## McMicken Dam Outlet Channel - Alternative 4

### FINAL Value Analysis Study Report Flood Control District of Maricopa County McMicken Dam Outlet Channel Project October 2014

**RE: McMicken Dam Outlet Channel Project  
Value Analysis Study–Final VA Report**

**SKETCH OF BASELINE**

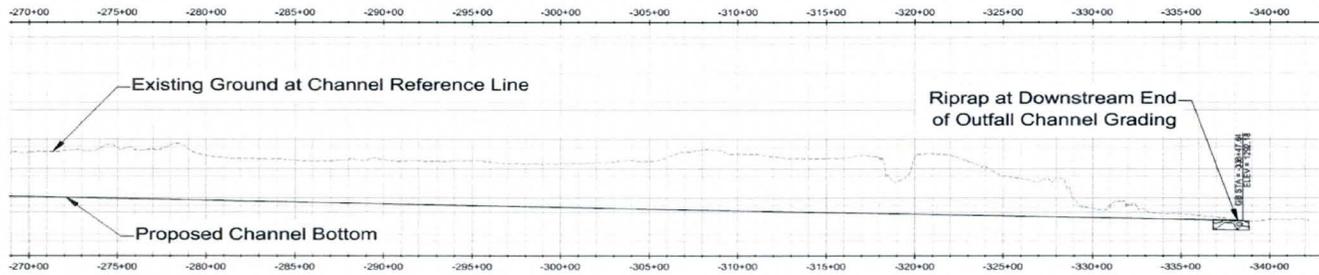
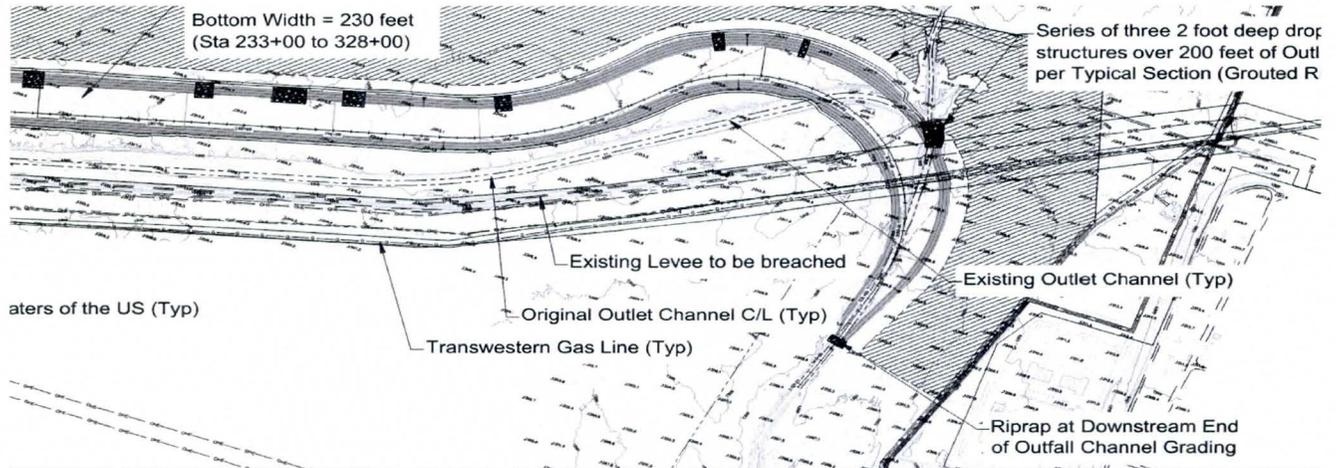
Alternative 3/4 hybrid design uses a 0.12% bed slope. Excavation depths range from 10 to over 12 feet deep, but normal depth required is only 6.7 to 7.27 feet and a freeboard of 2 feet. Deeper excavation may require more "hard dig" into caliche layers at a higher cost. Alternative 3/4 hybrid uses a wide curve to confluence with the existing wash, extending the length of the channel 500 feet. A milder slope of 0.10% is, by experience, non-erosive for most soils and reduces scour and sediment transport issues. Hydraulic analysis indicates that the same channel geometry can be used with the same bottom widths, but slightly higher flow depths (8 feet instead of 7 feet) while reducing excavation quantities as well as potentially reducing "hard dig" quantities. The milder grade allows for use of a 4-foot hydraulic drop at the outlet to the wash to dissipate energy and momentum while turning the flows 90 degrees.

SKETCH OF PROPOSED ALTERNATIVE

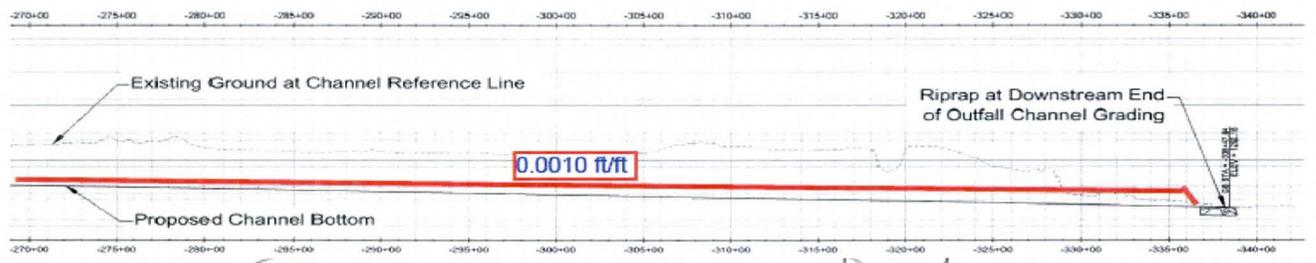
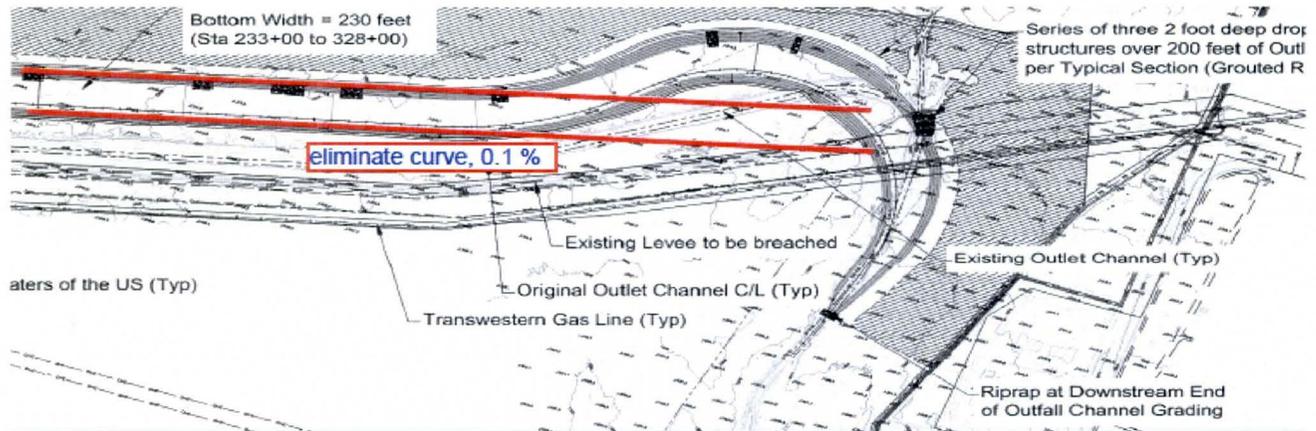
DD-01 (PROPOSED)	S=0.0012 BASELINE BW	$V_n$	Excavated dept.	S=0.001	BW	$V_n$	10	4:1
4450	100	7.27	12.5'-ft	100	8	10	4:1	
7025	170	7.18	12.5'	170	8	10	4:1	
9090	250	6.70	10	250	8	10	4:1

$$\frac{4.4 \times 22,000 \times 170}{2} = 304,741 \times 4 = 1,218,963$$

*Proposed*  
DD-4  
McMicken Dam Outlet Channel - Alternative 4

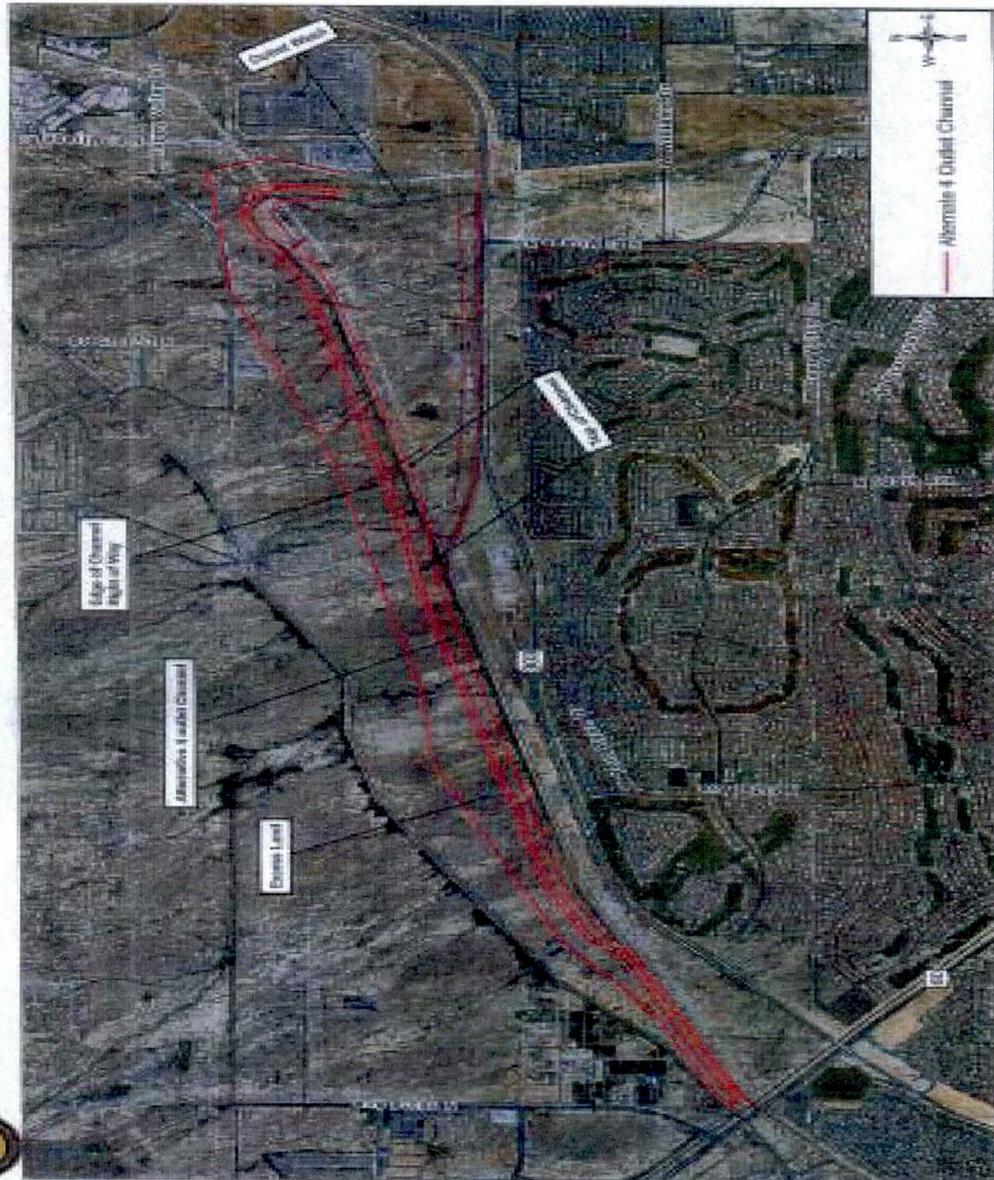
By moving the Outlet Channel south towards Loop 303, there is a possibility to provided continuous saleable property north of the realigned channel, which also releases more excess land of greater value for sale. The additional cost for purchasing land and crossing the Transwestern Gas line offsets the release of excess land. The net cost for the proposed alternative is more than the cost for the current Alternative 4/3 hybrid Alignment Outlet Channel, as noted on the detailed cost sheet. In order to review this further, there is a need to determine footprint of the Loop 303/El Mirage Rd traffic interchange. We have assumed current channel geometry. However the ground is lower to the south therefore channel geometry would need to reevaluated.

Based on above discussion, the proposed alternative is not recommended for further consideration.

**SKETCH OF BASELINE**

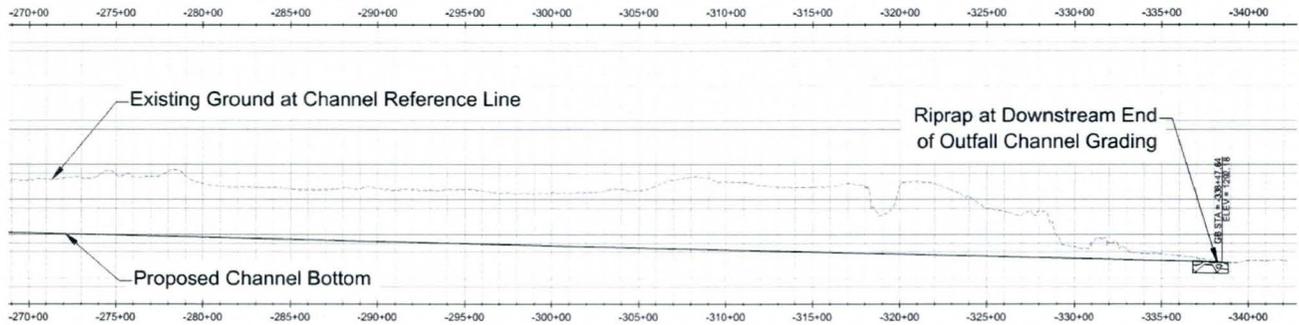
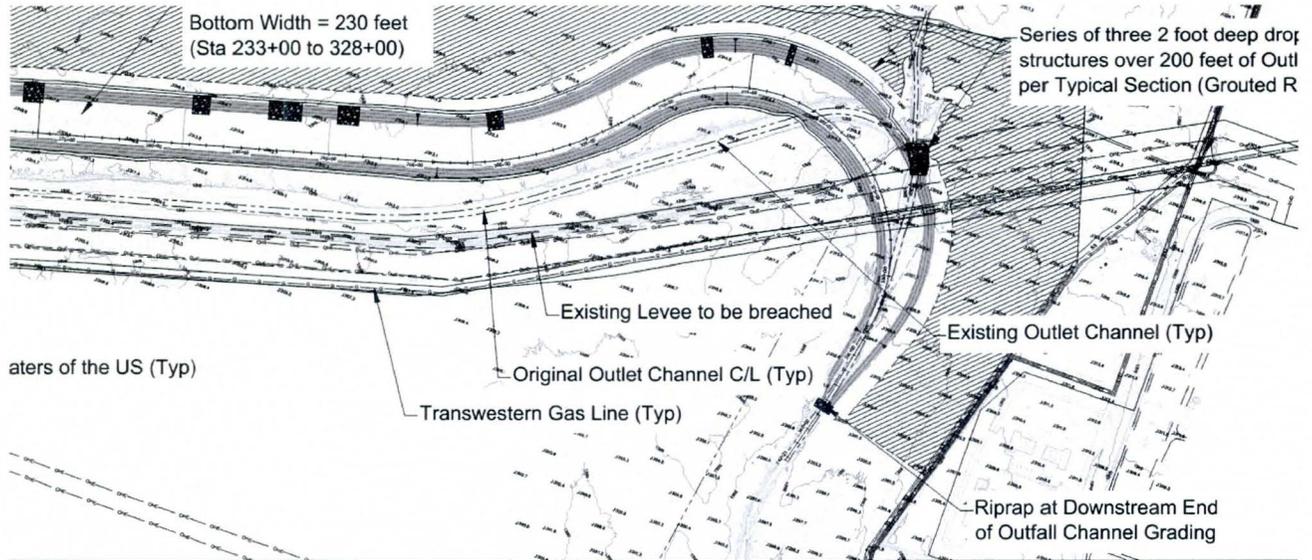
Alternative 3/4 hybrid uses a wide curve to confluence with the existing wash, extending the length of the channel 500 feet. Aligning the channel parallel to the levee reduces the channel length 500 feet and reduces excavation costs. To turn the flows 90 degrees, it is recommended to use a concrete structure, such as multiple-vaned training walls on a concrete slab.

**SKETCH OF BASELINE**

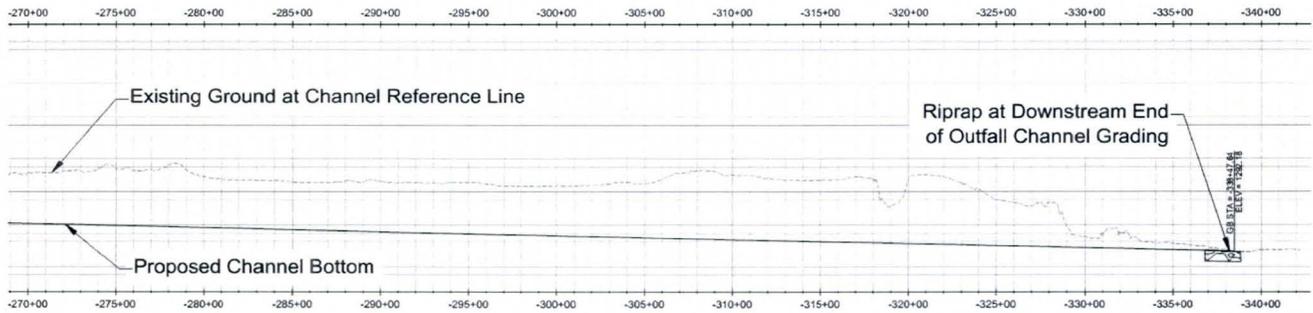
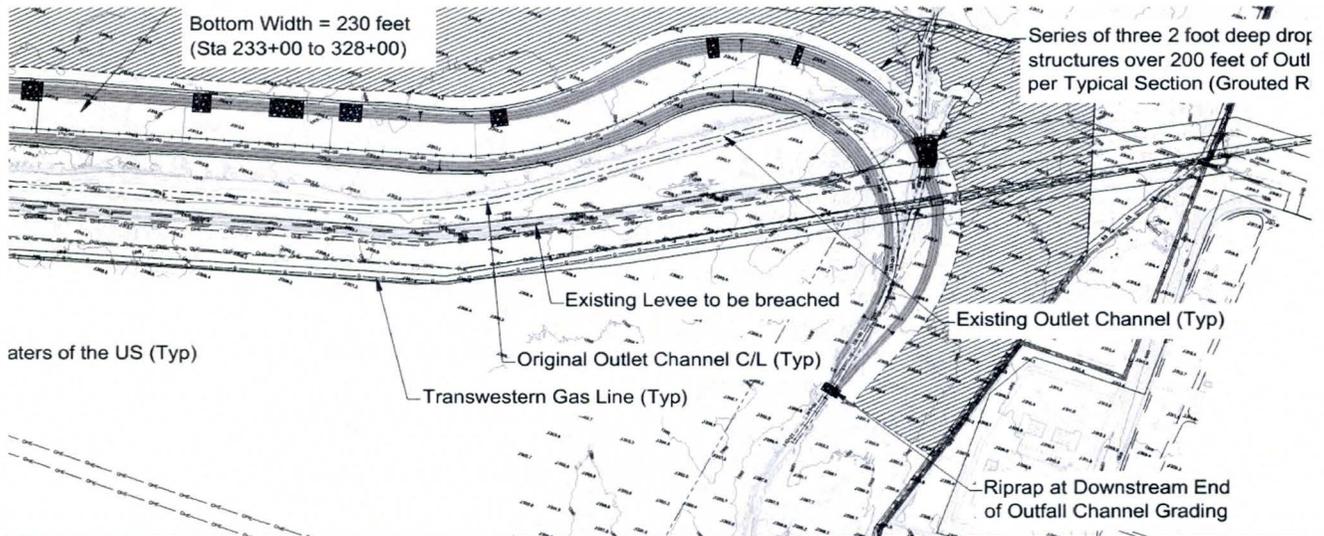
Alt ernative 3/4 hybrid uses a wide curve to confluence with the existing wash, extending the length of the channel 500 feet. Aligning the channel parallel to the levee reduces the channel length 500 feet and reduces excavation costs. It is recommended that to turn the flows 90 degrees, use a large boulder field set atop rip rap and a rip rap or gabion mattress at the opposite channel slope.

**SKETCH OF PROPOSED ALTERNATIVE**

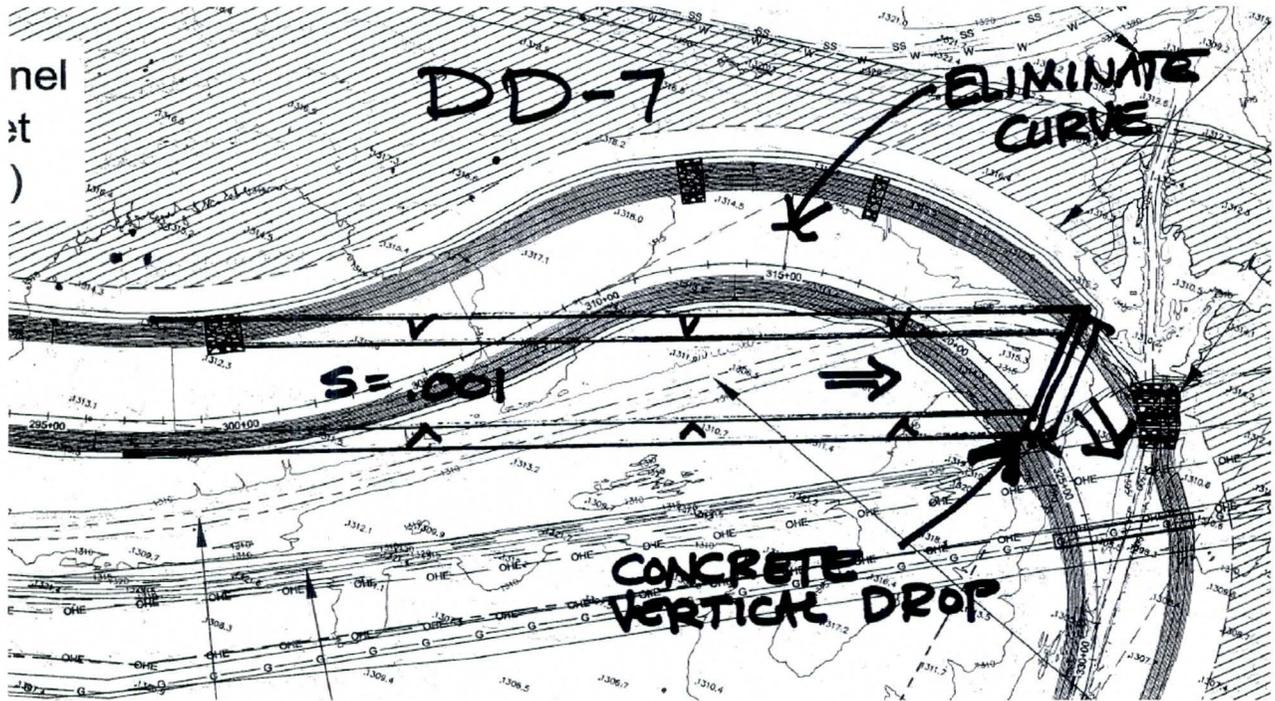
The baseline adds a curve to the existing channel to approach the wash with an acceptable radius and angle. This proposal replaces the curve with a concrete drop structure.

**SKETCH OF BASELINE**

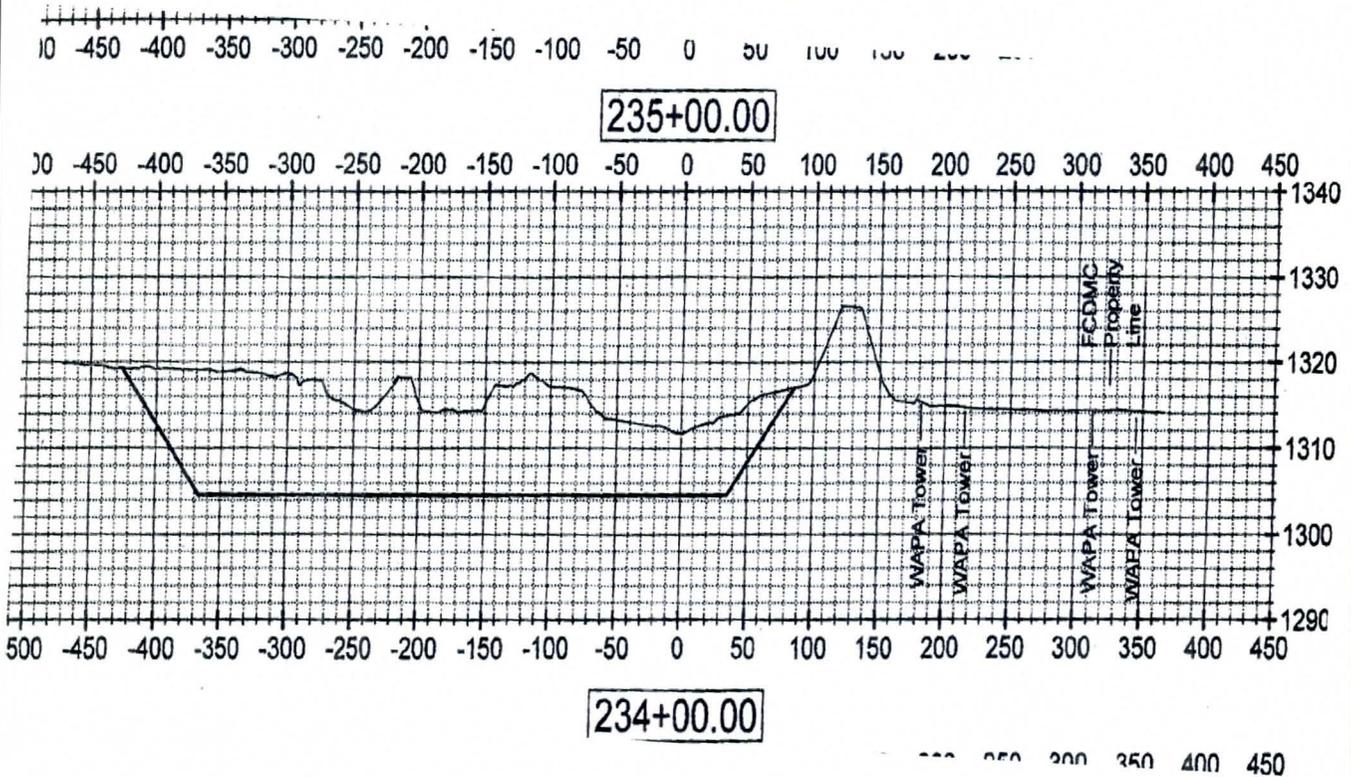
For the reach of channel downstream of where the WAPA lines leave the District right of way, the baseline project currently moves the channel adjacent to the toe of the levee. This will result in removal of the line of trees that provides landscaping and habitat. This proposal preserves the existing trees by splitting the channel; the conveyance would retain the existing low-flow channel and a new main branch of channel, beginning just north of the tree line. The tree line would be an "island" between the two channel branches, which would be connected in some locations. Although this could decrease the amount of excess right of way, the 100-foot buffer area on the north side could be decreased to compensate the right of way. This proposal assumes a channel invert of 0.001, which decreases the excavation quantity.

**SKETCH OF PROPOSED ALTERNATIVE**

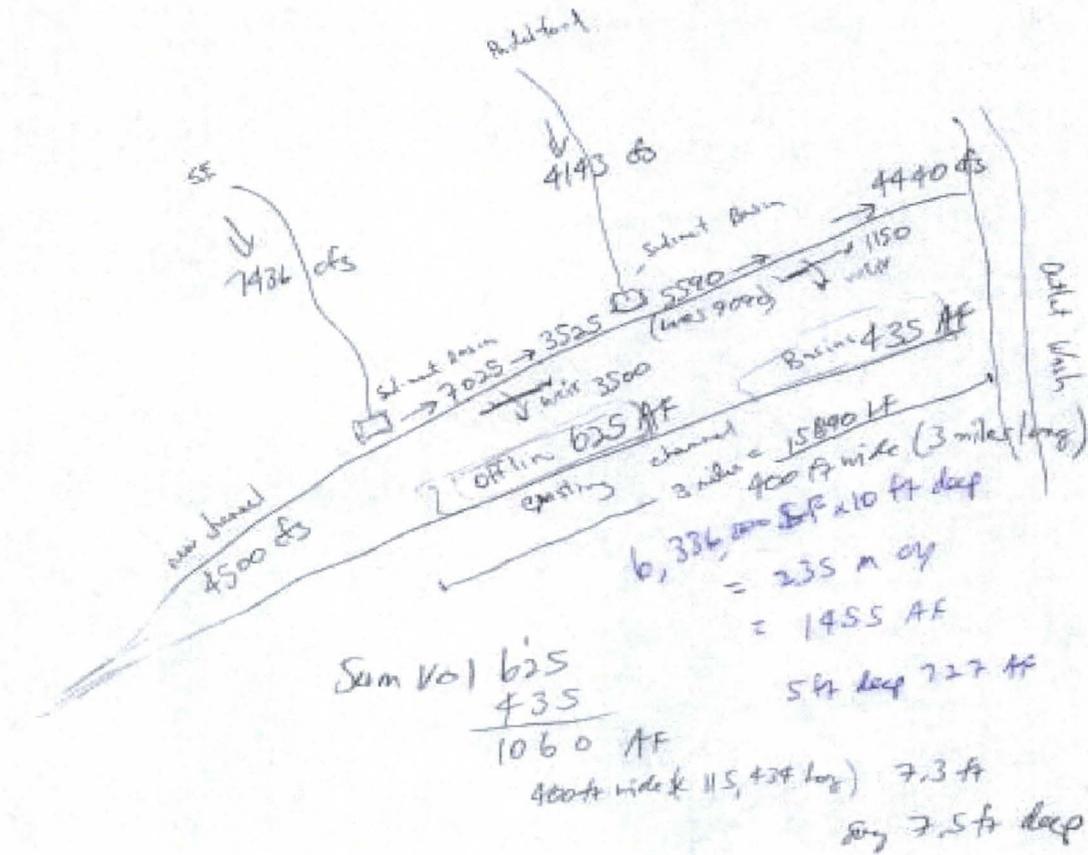
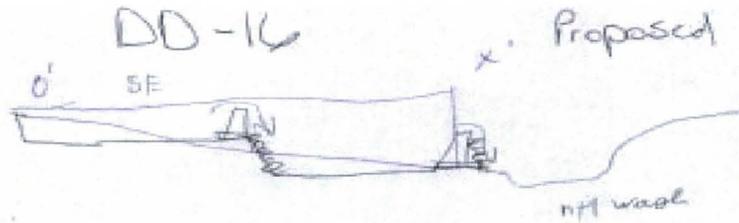
Use basins within the project area to reduce design flows in the excavated channel. To reduce excavation of offline basins and increase the amount of saleable land, the basins could be located in the footprint of the existing channel. These basins/channels should be optimized with more refined modeling such as unsteady HEC-RAS. This modeling would account for the storage in the flat, very long outlet channel. The basins could be located within the footprint of the existing outlet channel since this right of way will not be sold and is already partially excavated. The advantage may save new channel costs by using as much of the existing channel possible downstream of Padelford Wash. Sediment basins could be included at the outlets of the existing washes before entering the new channel. Groundwater recharge basins could also be incorporated into the offline basins. The reduction in the size of the channel will provide additional acreage north of the new channel to be available for sale and an increase in revenues to the District. See "Proposed Sketches" for computations.

PROJECT In Line Basins within ex.isting channel PAGE DD-21 OF       
 DETAIL      COMPUTED FRB DATE 16 Oct 2014  
 CHECKED BY      DATE

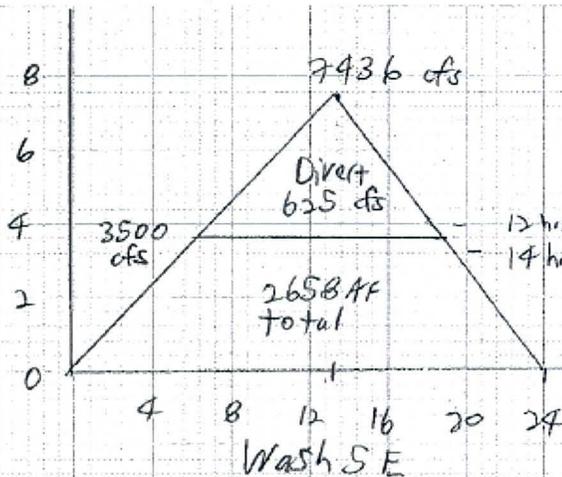
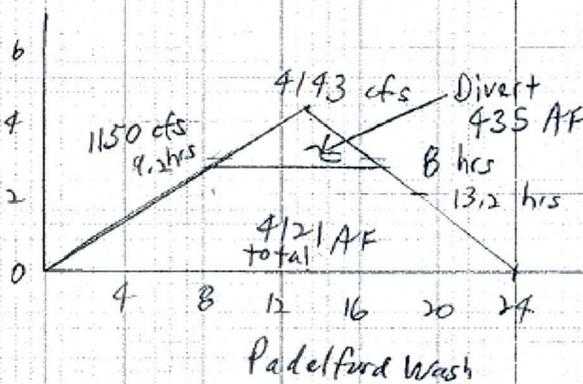
$$Volume = 3500 \frac{ft^3}{Sec} \left( \frac{3600sec}{hr} \right) 12 \text{ hrs of top } \left( \frac{1}{2} \right)$$

$$Vol = \text{above } \left( \frac{1 \text{ acre}}{43560 ft^2} \right) = 1735 \text{ AF}$$

[reduce by 0.36 factor of triangular vs. true hydrograph shape, 2658 for HEC-1 Vol]  $\frac{2658}{7375}$

$$Vol = \frac{625 \text{ AF}}{7375}$$

7436 cfs in  
 - 3500 cfs Direct to basin, 625 AF store  
 3936 cfs channel remainder
